ADDENDUM NO. 1

Date:	June 4, 2018	Owner:	ITD
Project:	<u>Spirit Lake Maintenance Shed Reroof</u>		
Project No.:	18-101	No. of Pages	3

EXTENDED EAVE OVER DECKING

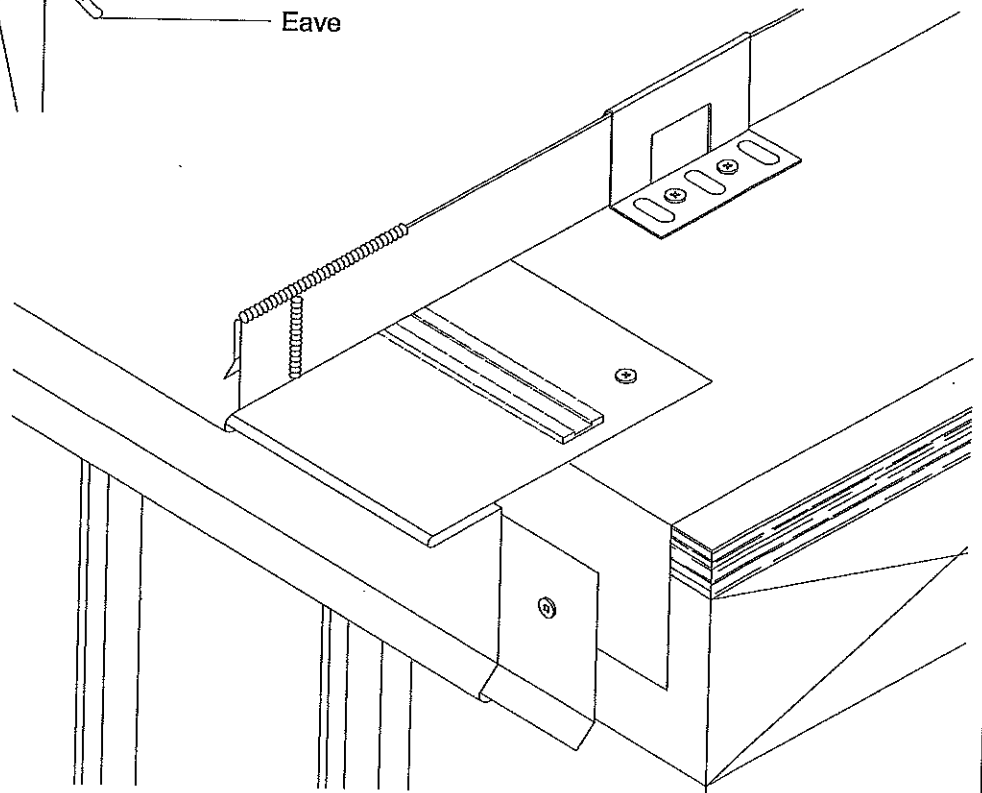
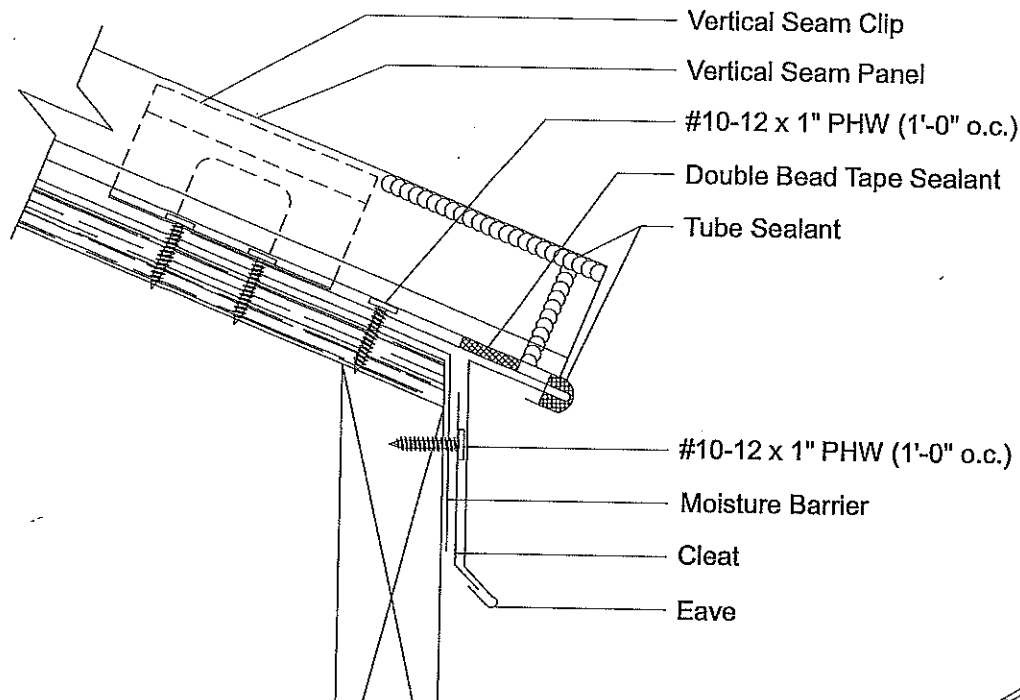
RESPONSE: Base bid for 26 GA metal panel to be standard mfg. paint coating. Alternate bid for 24 GA standing seam roof to be Kynar coated.
4. QUESTION:(Detail for Alternate) - Do you want the standing seam panel hemmed and locked into a drip edge or cleat? or do you want it overhung and fastened through the panel?

RESPONSE: Standing Seam Roof shall be locked in. See attached standing seam drip edge detail.
5. QUESTION: Will ITD pay for building permits.
RESPONSE: Yes, ITD will pay for building permits. Contractor is responsible for trade permits.

Note:
Panel rib must be
field notched and flat
part of panel must be
field bent to accept
Extended Eave
(see page 18).

All Eave flashings must be installed prior to panel installation.

1. Position and install Cleat to wall with appropriate fastener, 1'-0" o.c. Make sure Cleat allows for proper Extended Eave attachment.
2. Install Extended Eave flashing by sliding open hem onto Cleat and resting Extended Eave Flashing back against substrate. Fasten to substrate with #10-12 x 1" Pancake Head Woodscrew, 1'-0" o.c.
3. Apply a row of Double Bead of Tape Sealant to extended leg of the Extended Eave flashing.
4. Install panel by engaging field hemmed end of panel (see page 18) to Extended Eave (see pages 20-21 for panel installation).
5. If two or more flashings are required, lap the flashing over the previously installed flashing by a minimum of 2" placing a bead of Tube Sealant between the flashings and securing with pop rivets 2 1/2" o.c.
